TESTIMONY OF THE MAPLEWOOD CITIZENS ASSOCIATION

RE: STATE HIGHWAY ADMINISTRATION MANDATORY REFERAL PROPOSED INTERSECTION IMPROVEMENTS

West Cedar Lane and Rockville Pike (Route 355)

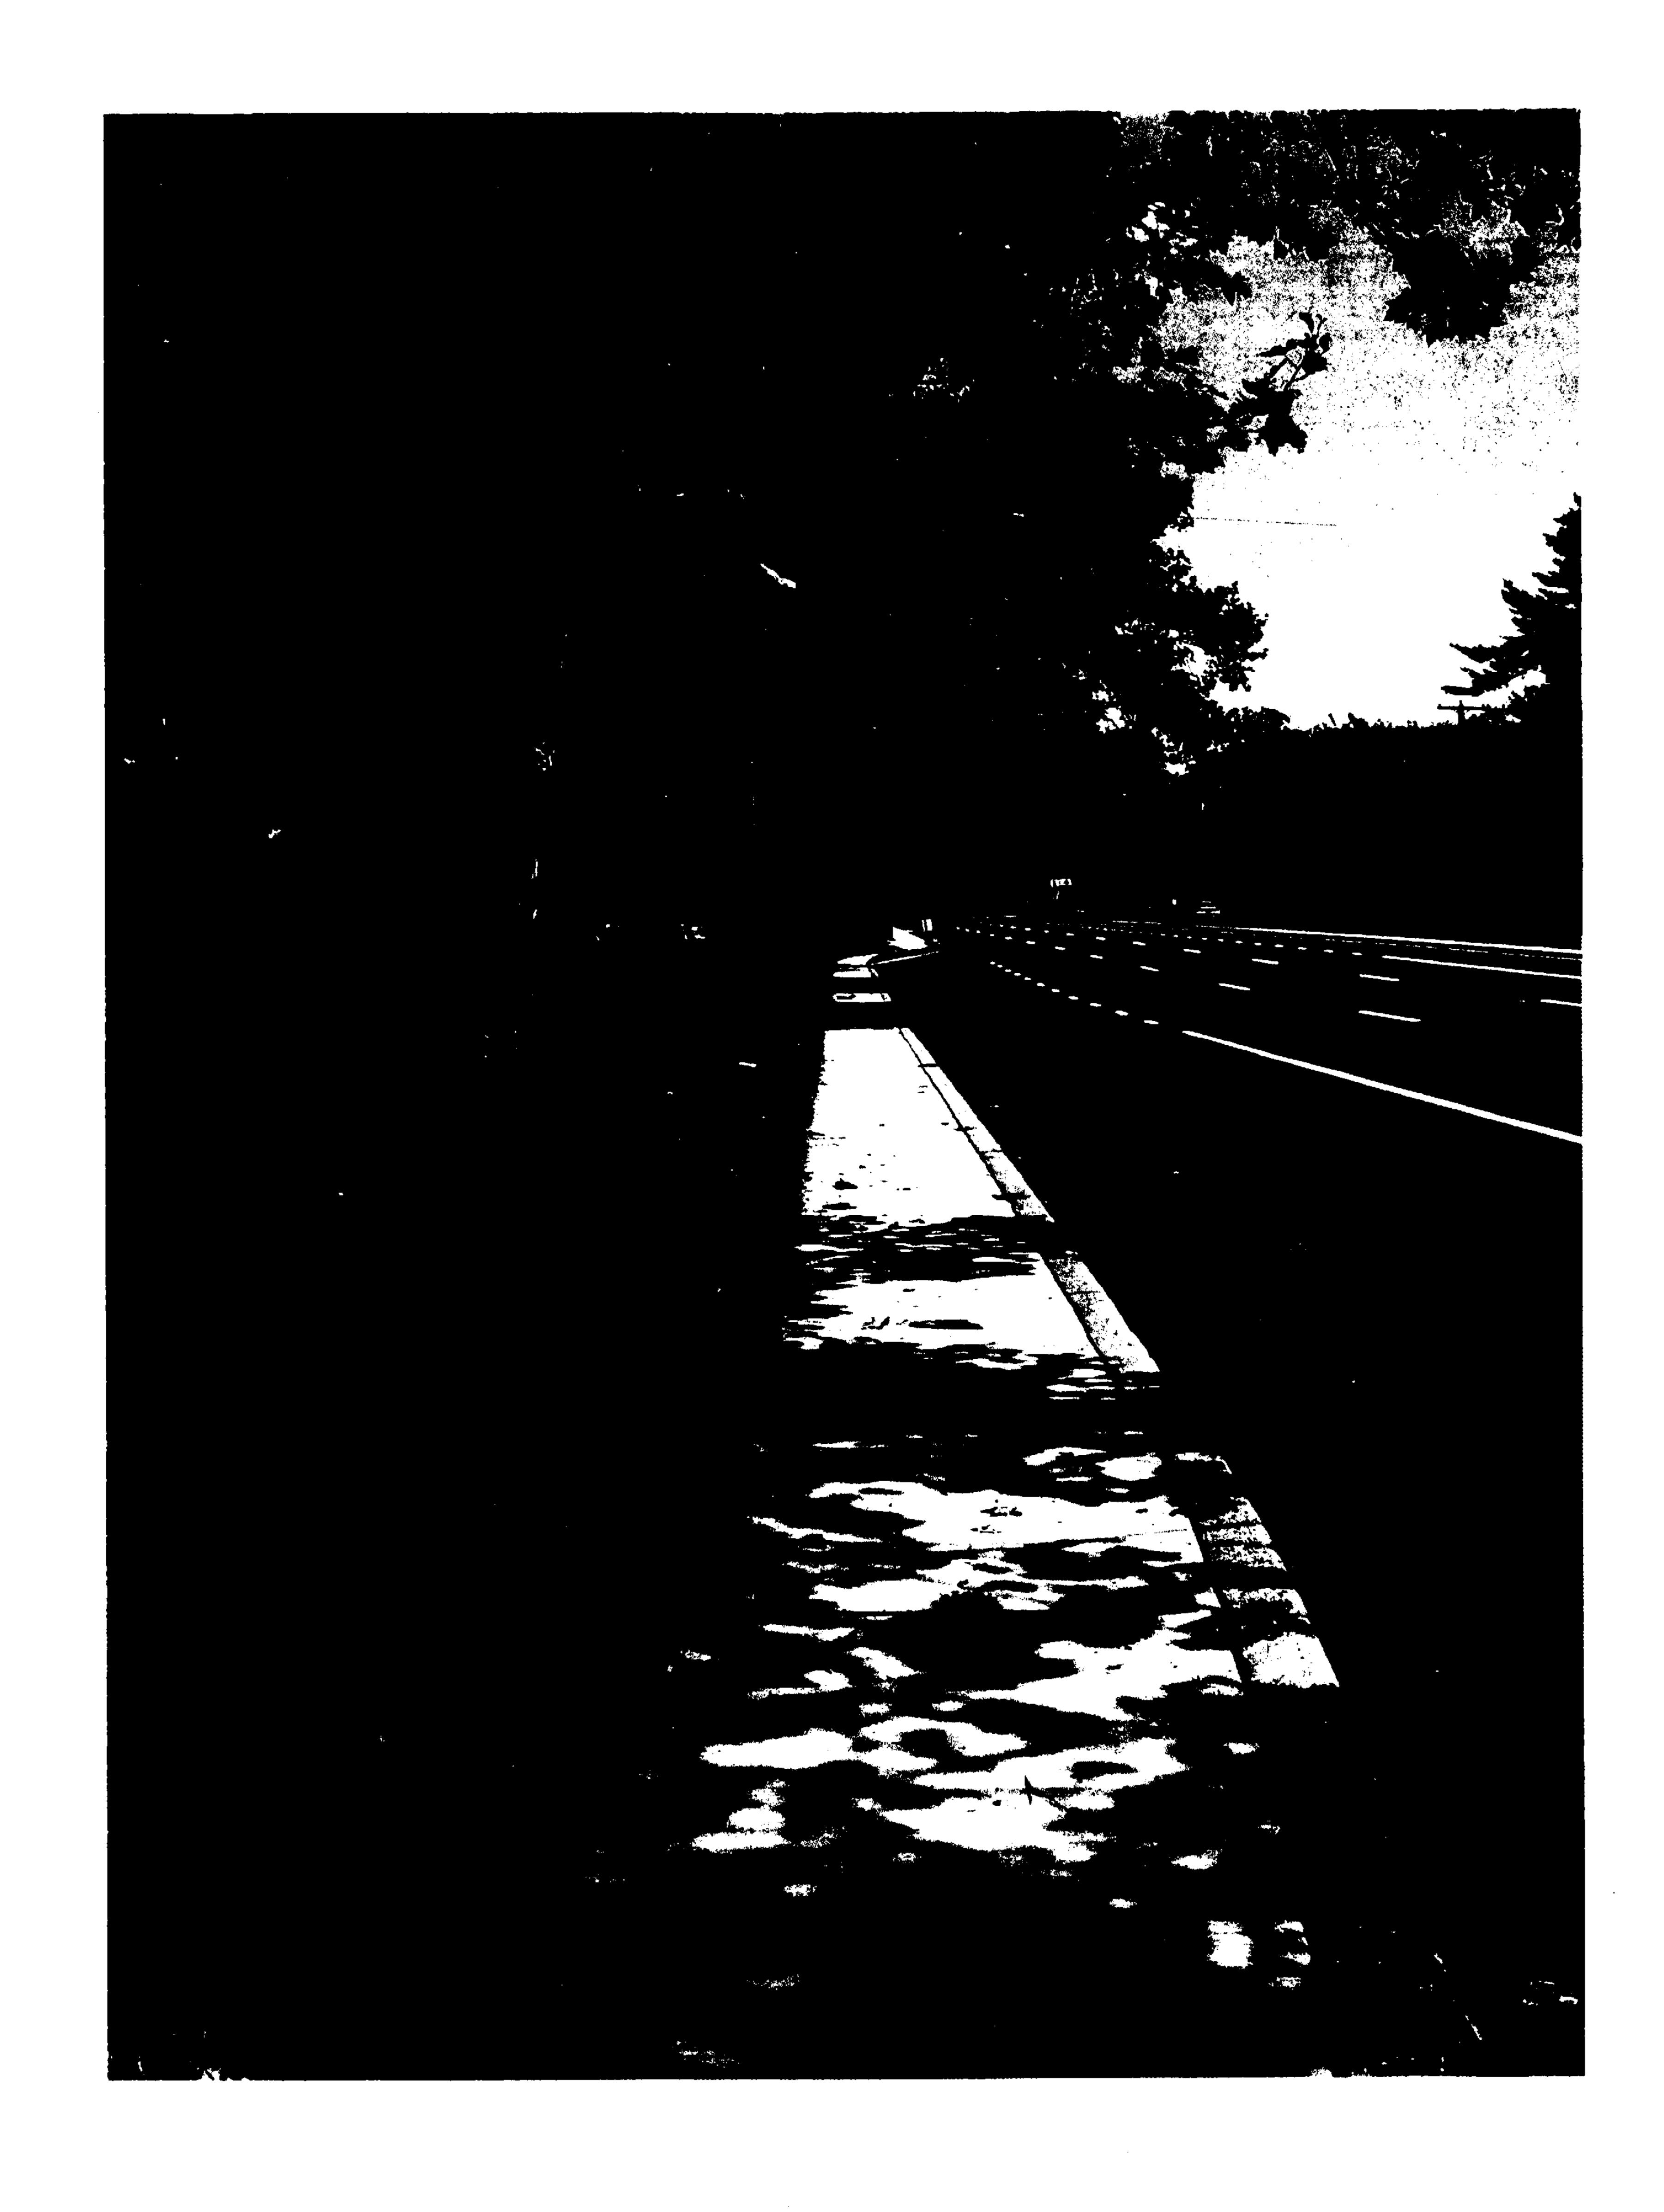
First, the diagram for existing eastbound lanes of West Cedar Lane at MD 355 shows a right-turn lane where none currently exists. There are currently the following lanes: a dedicated left-turn lane, a through and left-turn lane, and a through and right-turn lane. Right turns are accomplished by the means of a "free-right turn island" (proposed for elimination) at the intersection with space to hold two average-sized vehicles waiting to make a right turn.

Additionally, the project description calls for the removal of the split-phase signal for Cedar Lane and West Cedar Lane. At the same time, an additional dedicated left-turn lane is proposed for each of these roads. These two actions appear to be a recipe for "demolition derby" as through traffic attempts to negotiate its way through turning traffic and vice versa. The solution for this situation appears to be the continuation of the existing split-phase signal. Alternatively, signalization could be installed that separates the turning movements from the through traffic. However, this is lacking from the proposed project description. The staff analysis states:

The crosswalks on the west and east legs of the intersection exceed AASHTO (American Association of State Highway and Transportation Officials) guidelines for the provision of pedestrian refuges. The Cedar Lane leg is slightly over the recommended distance at 68 feet versus the AASHTO recommended 60 feet. The West Cedar Lane crosswalk is 88 feet long. While it would be desirable to have these pedestrian refuges, accommodating them would adversely affect the design of the stormwater (sic) management pond at the northwest corner of the intersection if the alignment of the through lanes is to be maintained. Therefore, we will forego a recommendation to provide these refuges.

MCA vigorously objects to this analysis. This is clearly a case of designing an intersection for vehicles and other purposes to the detriment of pedestrian safety and directly contradicts general recommendation #1 (from the Staff Recommendations and Executive Summary) to "make additional area bicycle and pedestrian improvements needed to provide safe and convenient access to NIH and NNMC campuses..." Moreover, the noted storm water management pond is proposed to be located on the <u>northeast corner</u> of the intersection and not the <u>northwest</u>. We urge that the design of the intersection provide for pedestrian refuge as recommend in ASHTO guidelines.

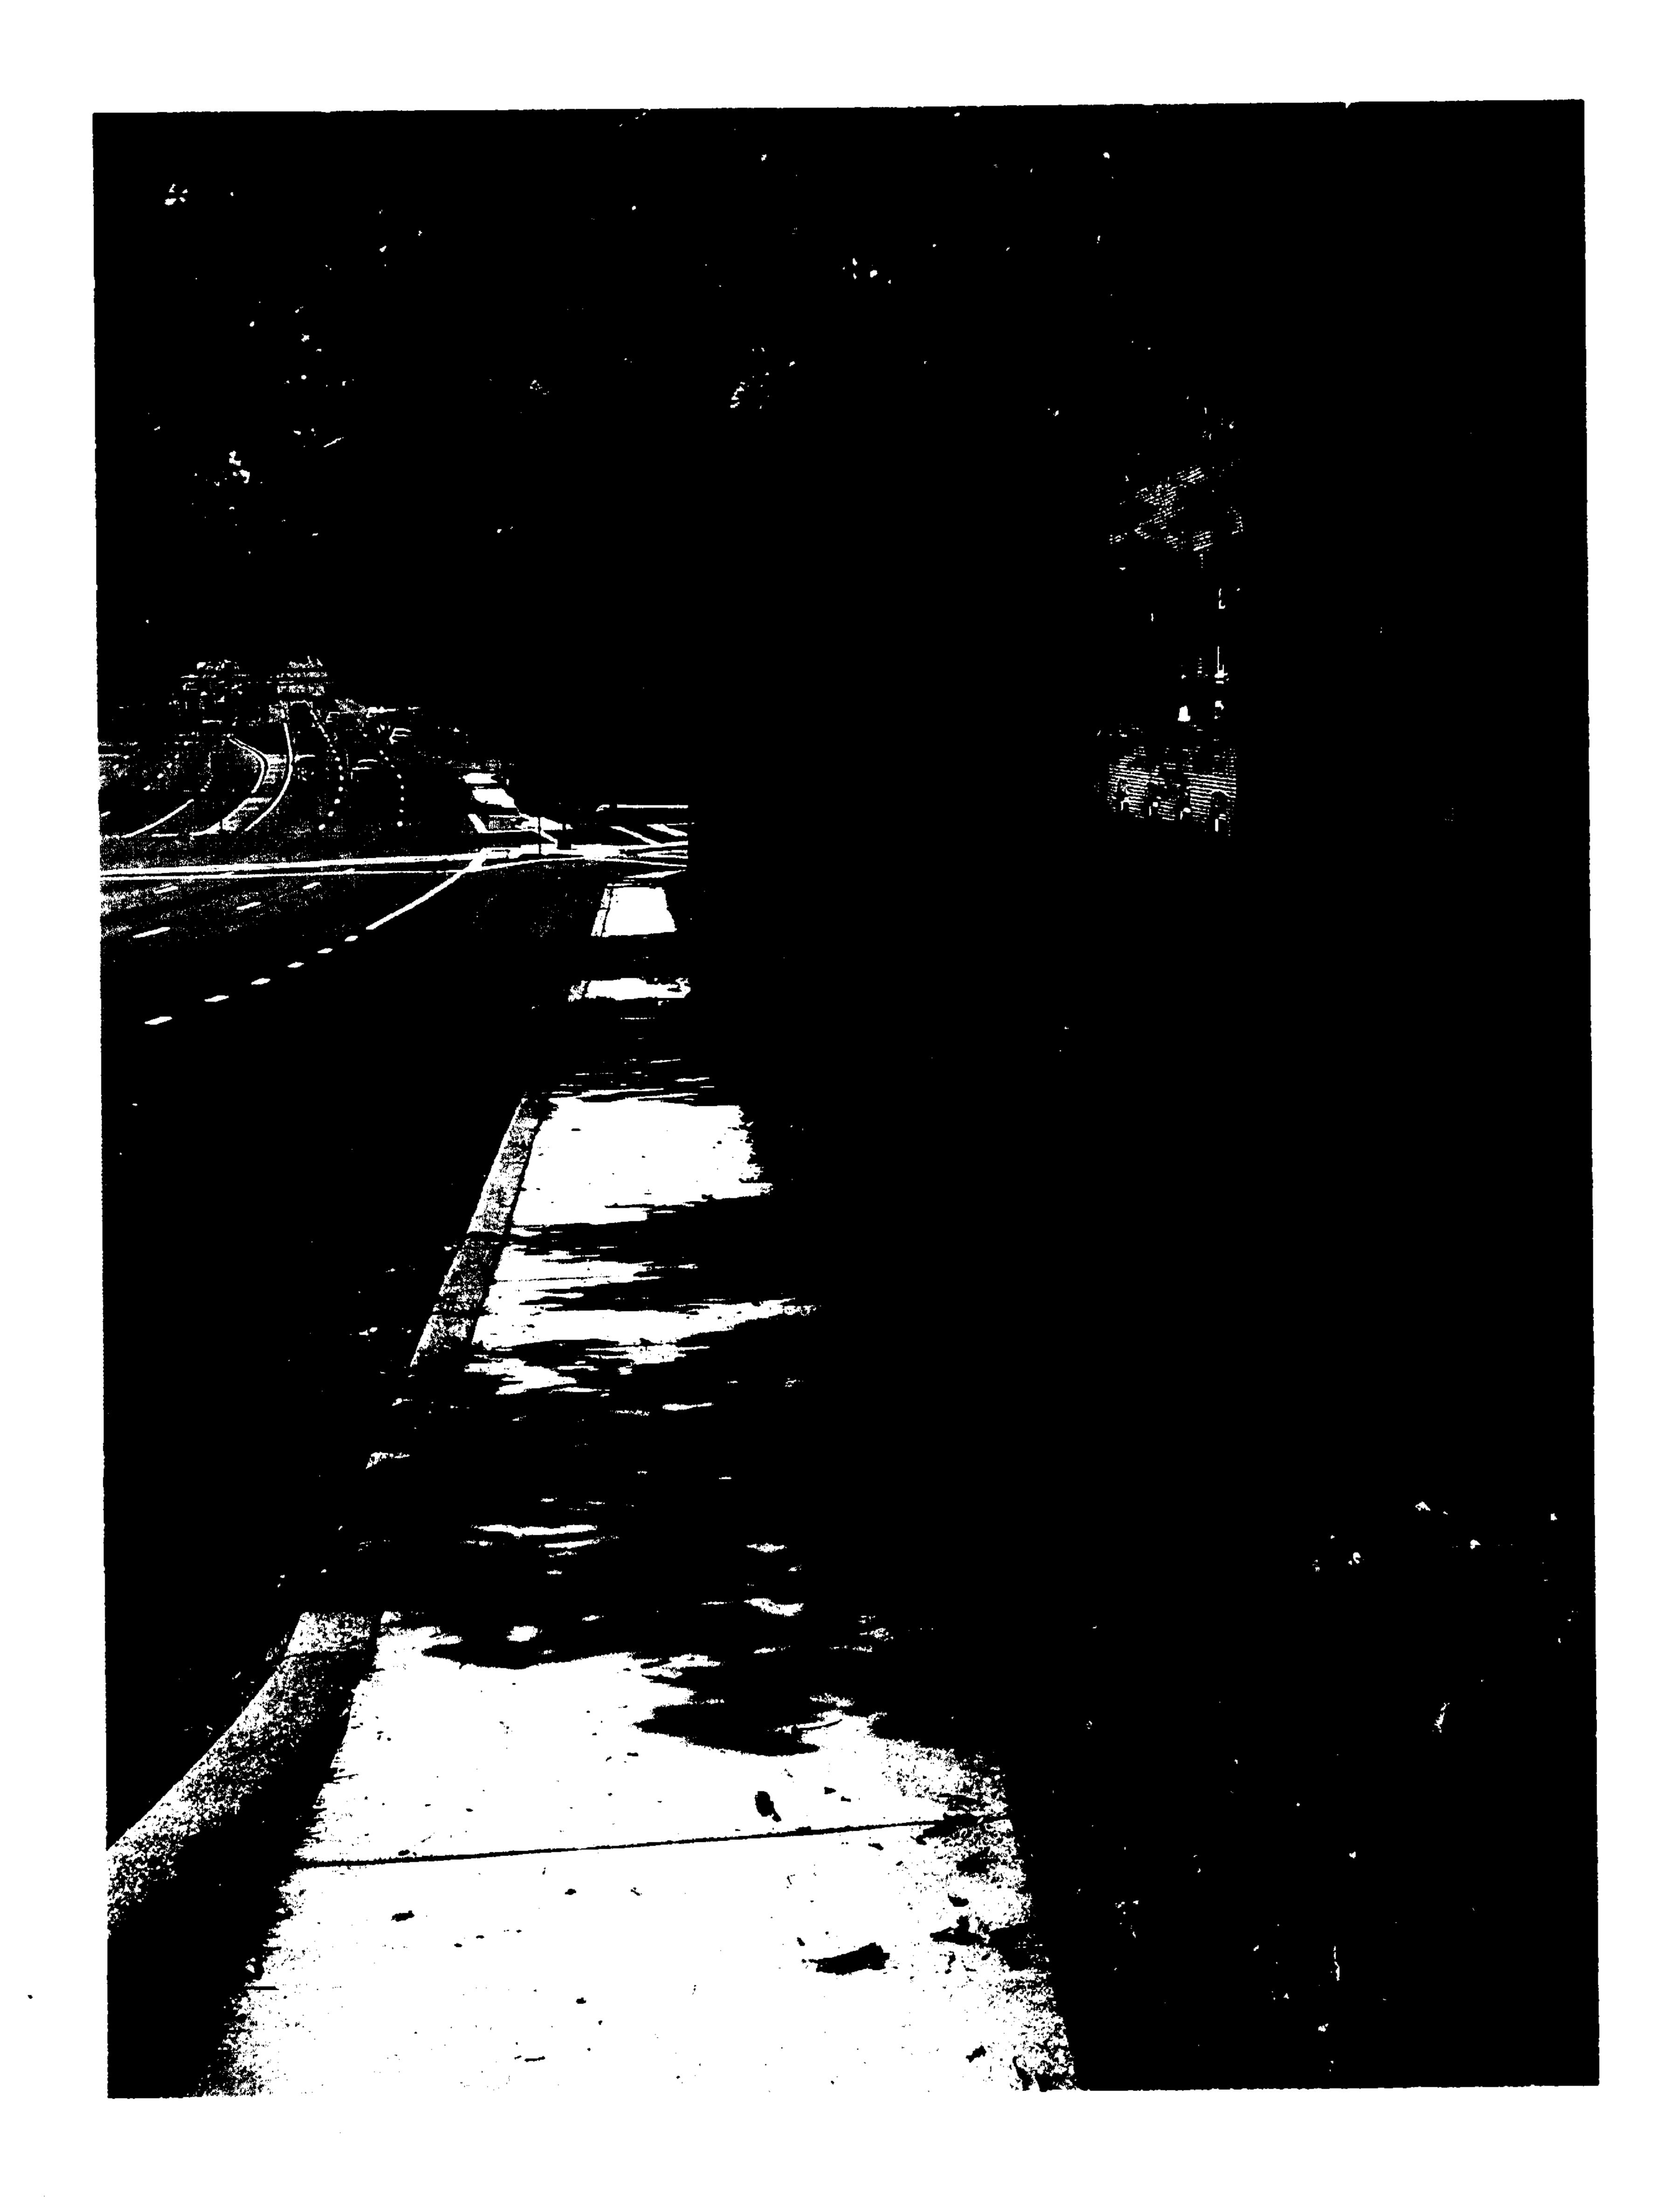
The existing sidewalk at this location is four feet – the same width as the sidewalk to the North, except for in front of Bethesda Crest where it varies between five and six feet. It is also the same width as the current sidewalks on the North and South sides of West Cedar Lane. As can be seen from the following three photographs, widening the sidewalk an additional foot will require removal a stand of lovely sycamore trees. Additionally, you will note that there is no "tall slope" justifying the need of a retaining wall.

Indeed, the existing walk, grassy area, and tree canopy provide a much more pleasant experience for pedestrians than immediately to the North.

In short, MCA believes that there is no need for a retaining wall and that the existing sidewalk on the NW corner of the intersection should be maintained.
